# SUPPLEMENTARY REPORT TO THE JOINT REGIONAL PLANNING PANEL

JRPP No	<b>2016STH037</b>
DA Number	<b>DA-2016/1719</b>
Local Government Area	Wollongong City
Proposed Development	Mixed use development - ground and mezzanine level commercial with 92 residential apartments over two (2) basement carparking levels including demolition of existing concrete hardstand surface
Street Address	Lot 1 DP 1202226, 38 Atchison Street, Wollongong
Applicant/Owner	Applicant - PRD Architects; Owner – Pars Holdings Pty Ltd
Number of Submissions	One submission in support of the proposal
Regional Development Criteria (Schedule 4A of the Act)	Clause 3, Schedule 4A of the Environmental Planning & Assessment Act 1979; general development over \$20 million. The applicant's CIV estimate for the project is \$27,177,997.
List of All Relevant s79C(1)(a) Matters	<ul style="list-style-type: none"> <li>• List all of the relevant environmental planning instruments: s79C(1)(a)(i) –</li> </ul> <p><u>State Environmental Planning Policies (SEPPs):</u></p> <ul style="list-style-type: none"> <li>▪ SEPP No. 55 – Remediation of Land</li> <li>▪ State Environmental Planning Policy No 65—Design Quality of Residential Apartment

Figure 2: Extract of eastern elevation showing the relationship between the existing building at No.34 Atchison Street and the proposed building.

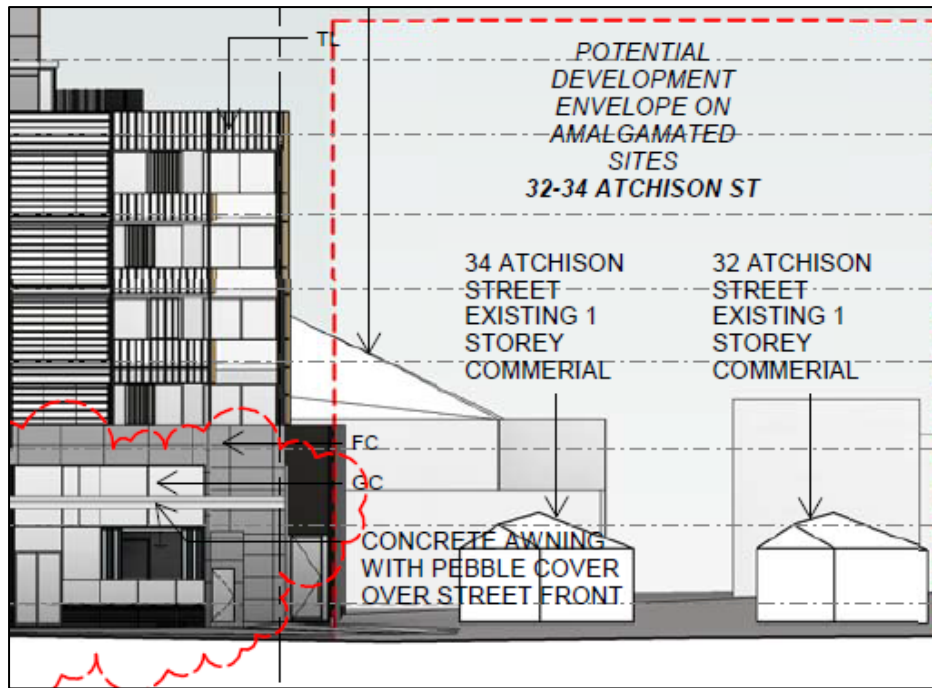
In terms of the northern boundary, Clause 8.6(2)(a) requires there to be no separation between neighbouring buildings up to the street frontage height of the relevant building or up to 24 metres above ground level (whichever is the lesser). To the north of the site, there exists only a single storey building which has the form of a residential dwelling but is however occupied by a beauty salon, ie. is used solely for commercial purposes:

As illustrated in this photo, the neighbouring building is setback approximately 3.5m from its southern boundary (ie. the common boundary with the subject site). The proposed building will be built to the northern boundary.

There is no potential to provide for a zero building separation to this adjacent building due to its setback from the common boundary between the two sites. However with any future re-development of that site, it is anticipated that a future building can be designed to achieve a continuous street wall to the commercial component of the development as required by the LEP and Chapter D13 of WCP 2009.

To the northern boundary, there is no technical departure from Clause 8.6 in relation to any other part of the building above the height of the neighbouring building to the north.

Figure 4: Extract of eastern elevation showing the relationship between the existing building at No.44 Atchison Street and the proposed building.

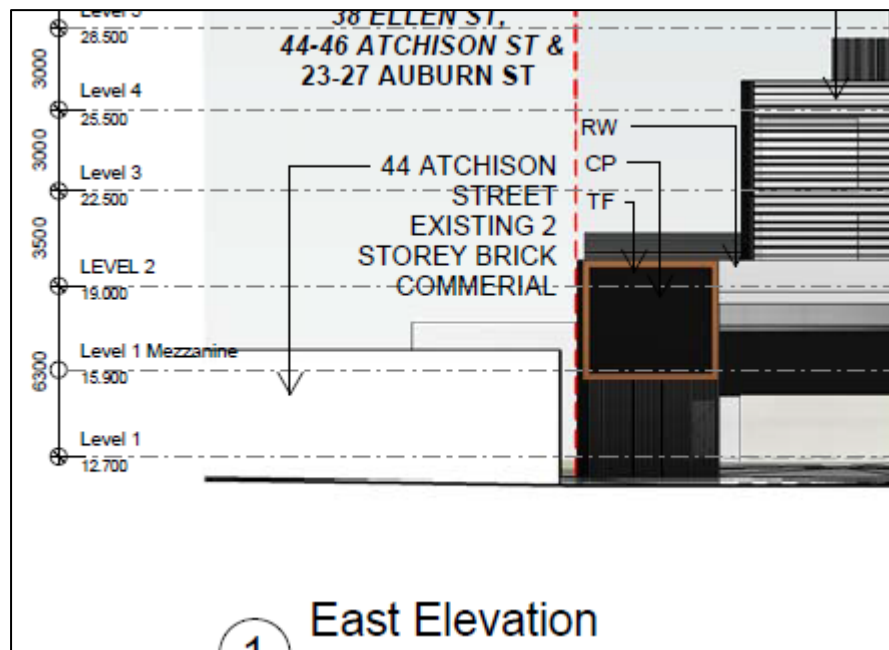
Clause 8.6(2)(a) requires there to be no separation between neighbouring buildings up to the street frontage height of the relevant building or up to 24 metres above ground level (whichever is the lesser). The variation in respect of Clause 8.6(2)(a) relates only to that part of the proposed development at the equivalent height of the neighbouring building, ie. to approximately the mezzanine level:

The departure is a technical non-compliance arising only due to the fact that the neighbouring building within No.44 Atchison Street is not built to its northern boundary, creating a gap between the two buildings. The proposed building is to be built to the boundary as required.

There is no potential to provide for a zero building separation to this building due to its setback from the common boundary between the two sites. However with any future re-development of that site, it is anticipated that a future building can be designed to achieve a continuous street wall to the commercial component of the development as required by the LEP and Chapter D13 of WCP 2009.

To the southern boundary, there is no technical departure from Clause 8.6 in relation to any other part of the building above the height of the neighbouring building to the south.
